S/D 97-52 Preliminary Plat of WESTLINK CHRISTIAN CHURCH ADDITION
July 24, 1997 - Page 2

S/D 97-52 Preliminary Plat of WESTLINK CHRISTIAN CHURCH ADDITION
July 24, 1997 - Page 3

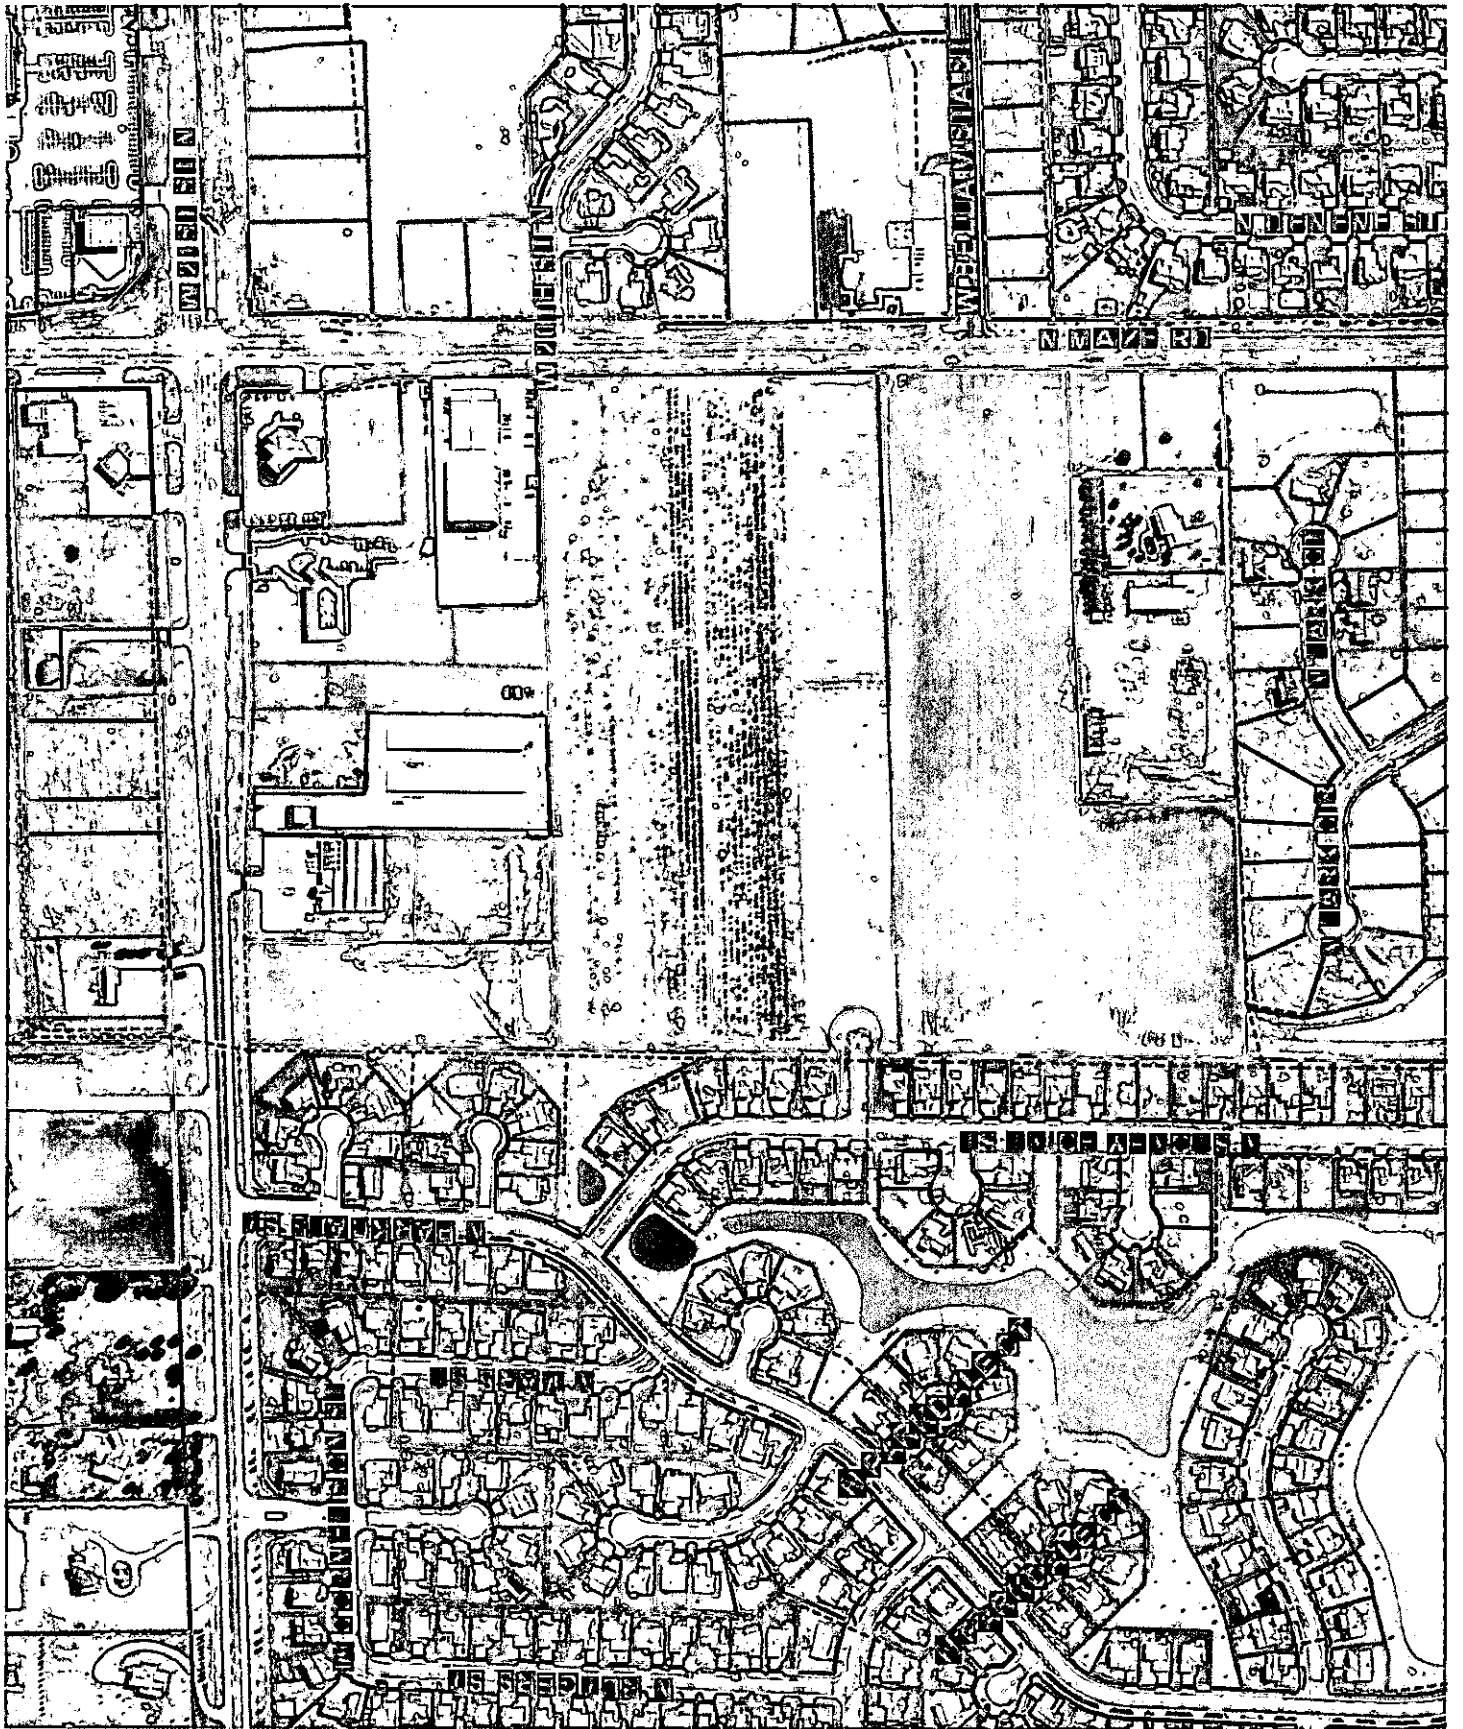
- A. This site has City water and sanitary sewer. **City Engineering** needs to verify if any other guarantees are required, i.e. sewer, water, drainage and so forth.

- B. The applicant shall guarantee any drainage improvements required by the platting of this property.
- C. If improvements are guaranteed by petition, a notarized certificate listing the petitions shall be submitted to the Planning Department for recording.

- D. **Traffic Engineering** needs to comment on any improvements needed along Maize Road as well as, if four access points along Maize Road are acceptable. Finally, **Traffic Engineering** should also discuss if a cul-de-sac for West Lawn is appropriate.

- G. The representatives from the **utility companies** should be prepared to comment on the need for utility easements to be platted on this property.

- H. The representatives from **City Engineer** should be prepared to comment on the status of the applicant's drainage plan.
- I. The applicant shall install or guarantee the installation of all utilities and facilities which are applicable and described in Article 8 of the MAPC Subdivision Regulations. (Water service and fire hydrants required by Article 8 for fire protection shall be as per the direction and approval of the Chief of the Fire Department.)

- J. The applicant shall correctly state the tie point as the NW CORNER, NE 1/4. Also the applicant needs to add distances between the tie point and the point of beginning.
- K. The applicant's agent is reminded that the plat binder is to be submitted with the final plat. This plat will be subject to review of the plat binder and any relevant conditions found by such a review.

- D. **Traffic Engineering** indicates the cul-de-sac for West Lawn is appropriate. Only three points of access shall be provided to Maize Road.
- E. Perimeter closure computations shall be submitted with the final plat tracing.

- H. The representatives from the **utility companies** should be prepared to comment on the need for utility easements to be platted on this property. No additional easements were required.

- I. The representatives from **City Engineering** should be prepared to comment on the status of the applicant's drainage plan. The drainage plan is approved, but onsite detention is required and can be built at the time of development.

- K. The applicant shall correctly state the tie point as the NW CORNER, NE 1/4. Also the applicant needs to add distances between the tie point and the point of beginning.

- L. The applicant's agent is reminded that the plat binder is to be submitted with the final plat. This plat will be subject to review of the plat binder and any relevant conditions found by such a review. A plat binder has been submitted.
